**Planning Commission Regular
Meeting**

Tuesday, September 26, 2023

AGENDA ITEM:	Request by Maplewood Development, Inc. for Approval of the Amber Fields 13th Addition Preliminary Plat.	AGENDA SECTION:	PUBLIC HEARINGS
PREPARED BY:	Julia Hogan, Planner	AGENDA NO.	6.a.
ATTACHMENTS:	Site Location, Existing Conditions; Preliminary Plat; Phasing Plan; Site Plan; Preliminary Grading and Drainage Plan; Preliminary Utility Plan; Landscape Plan , City Engineer's Memo Dated September 7, 2023	APPROVED BY:	AK
RECOMMENDED ACTION: 1. Motion to recommend the City Council approve the Preliminary Plat for Amber Fields 13th Addition, subject to: a. Conformance with all requirements of the City Engineer as detailed in the attached memorandum dated September 7, 2023. b. Approval of a Minor Amendment to the Amber Fields Planned Unit Development Agreement. c. Approval of the preliminary plat by the Dakota County Plat Commission. d. Payment of \$29,040 as a landscape surety. e. Payment of trunk area charges in the amount of: i. Sanitary Sewer Trunk Charge: \$1,075/acre ii. Watermain Trunk Charge: \$6,500/acre iii. Storm Sewer Trunk Charge: \$6,865/acre

Re: Amber Fields 13th Addition Civil and Stormwate

STORM SEWER PLAN

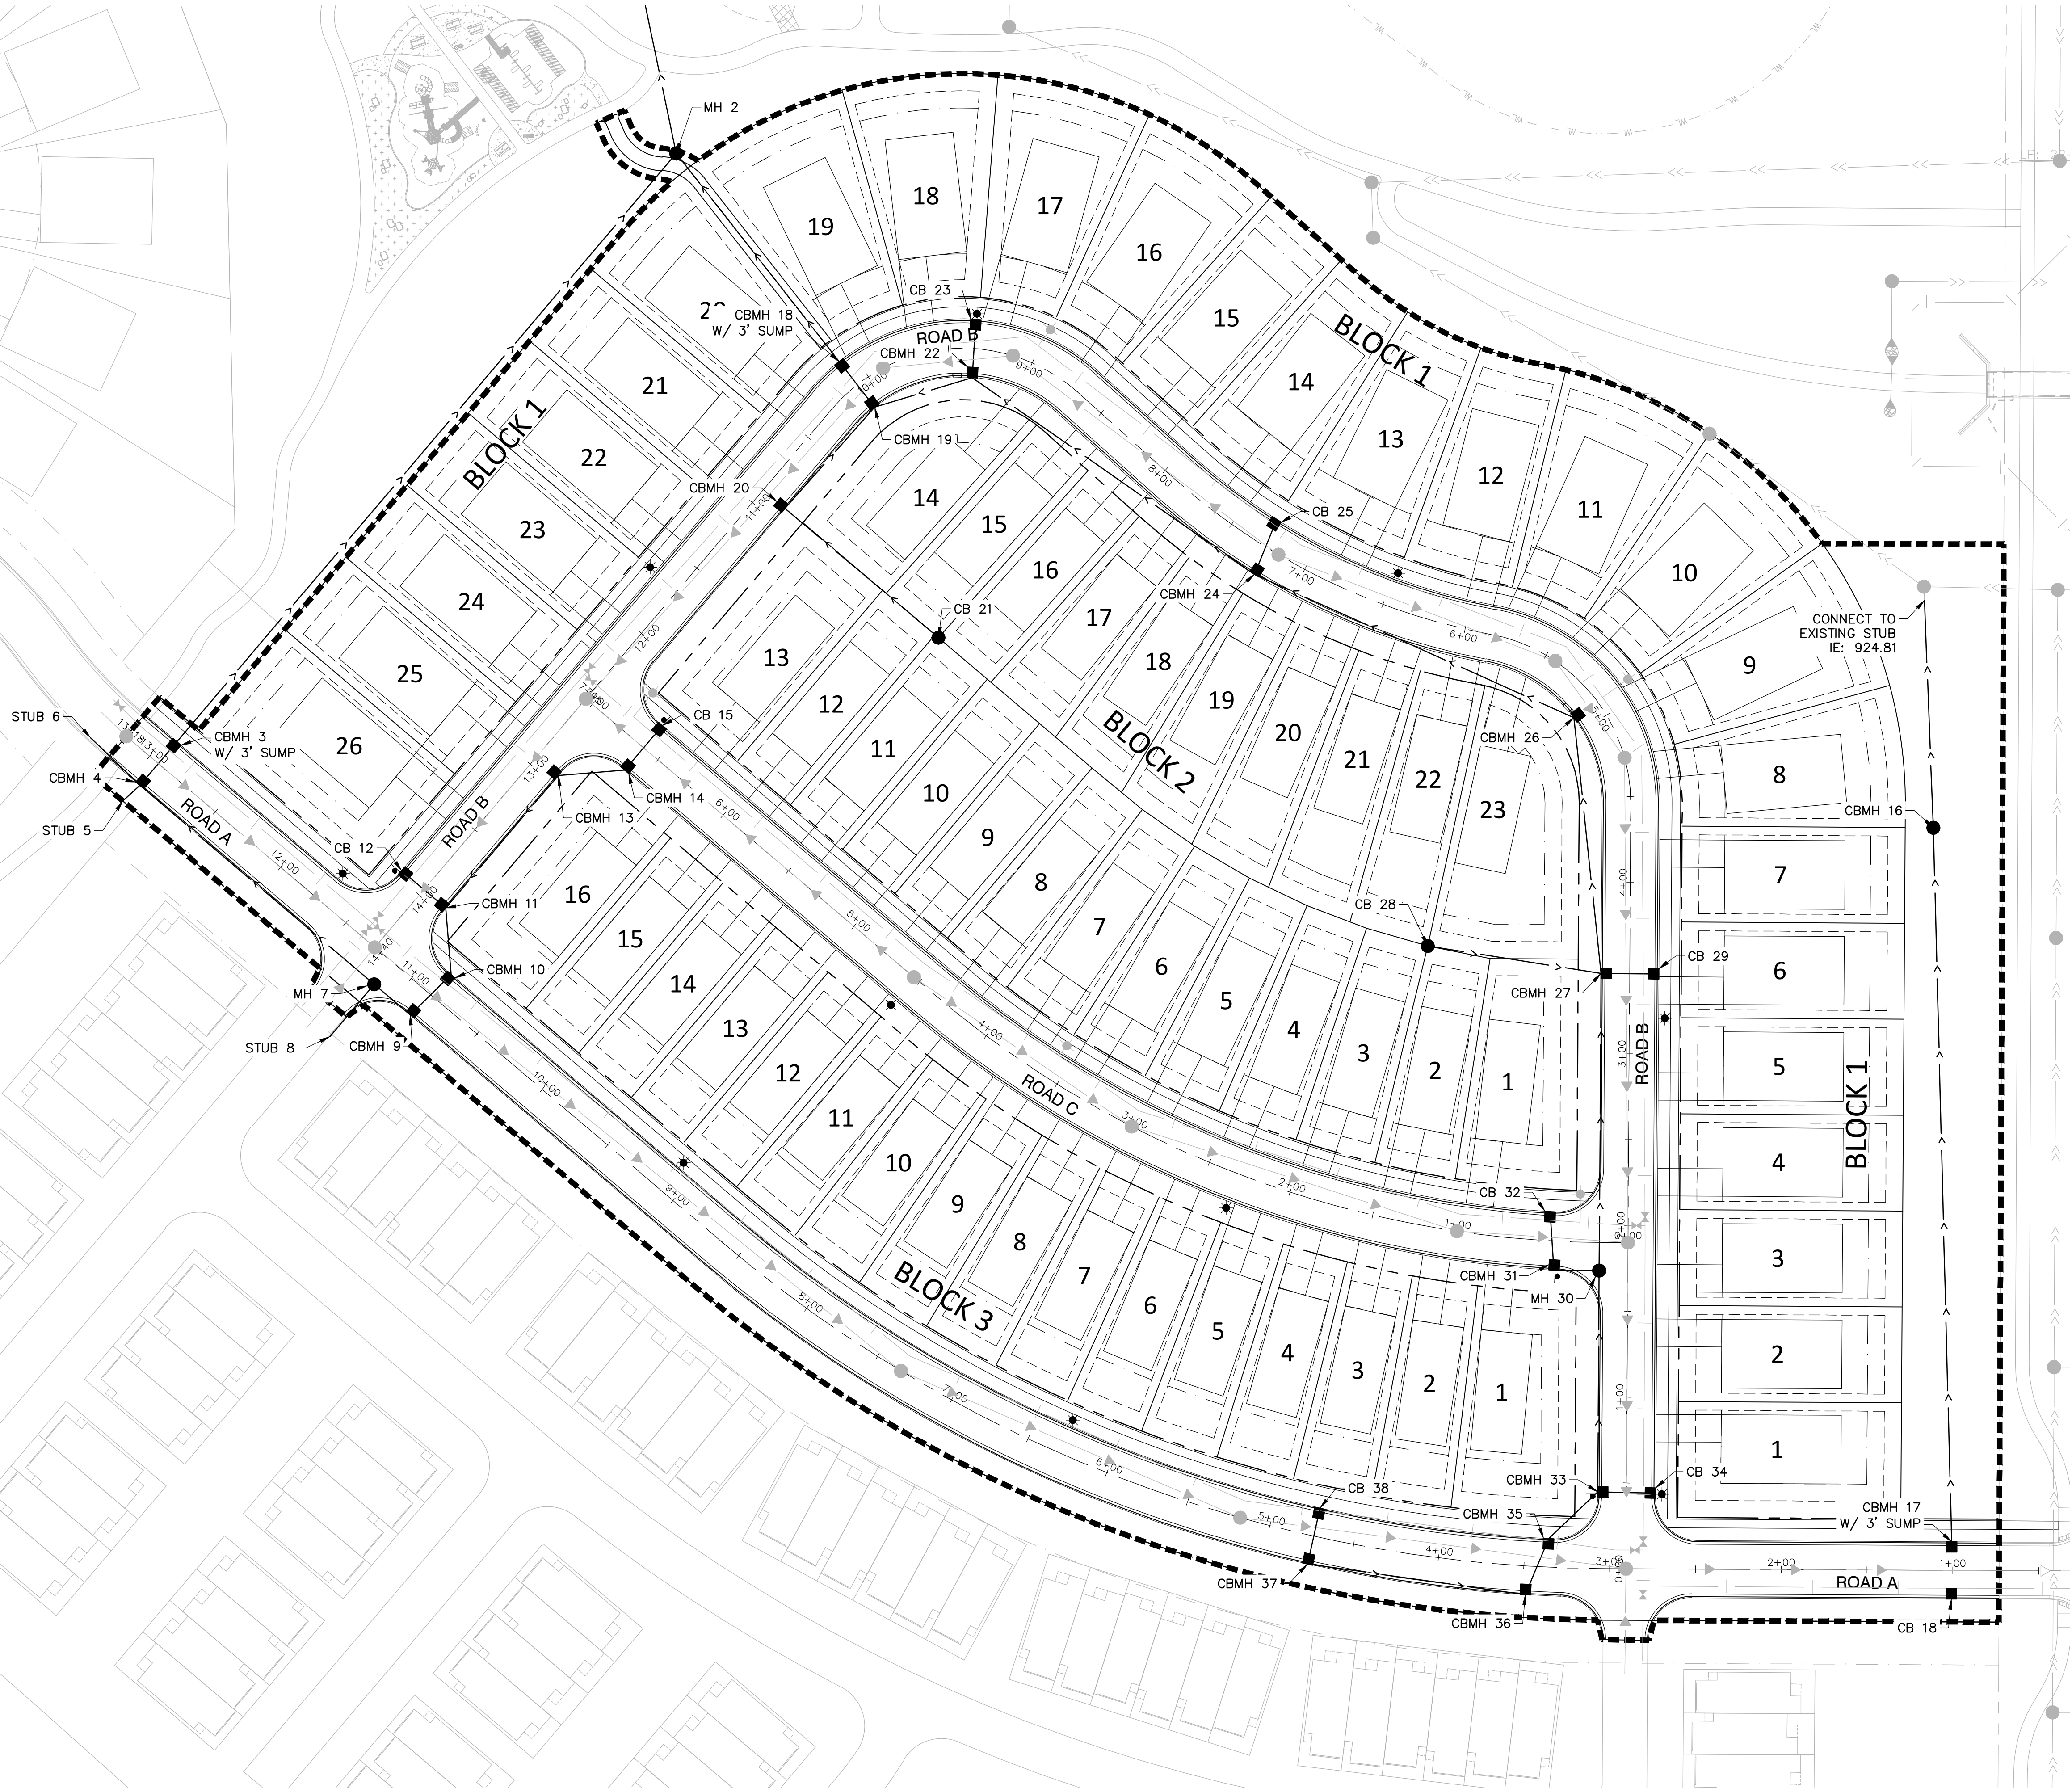
- d. It is assumed CB 18 will connect to CBMH 17; update linework on storm sewer plans.
 - e. FES 1 will require sheet piling due to the proposed pipe size; this should be included in final plat plans.

- a. Easement near CBMH 27 should be updated to provide 10 feet south of the proposed storm sewer line (or structure CBMH 27 should be shifted to the lot line – see comment provided under the grading section).
- b. Provide structure and pipe depth information for the STMH at the back of Block 1, Lot 10/11 to determine if additional easement is required.
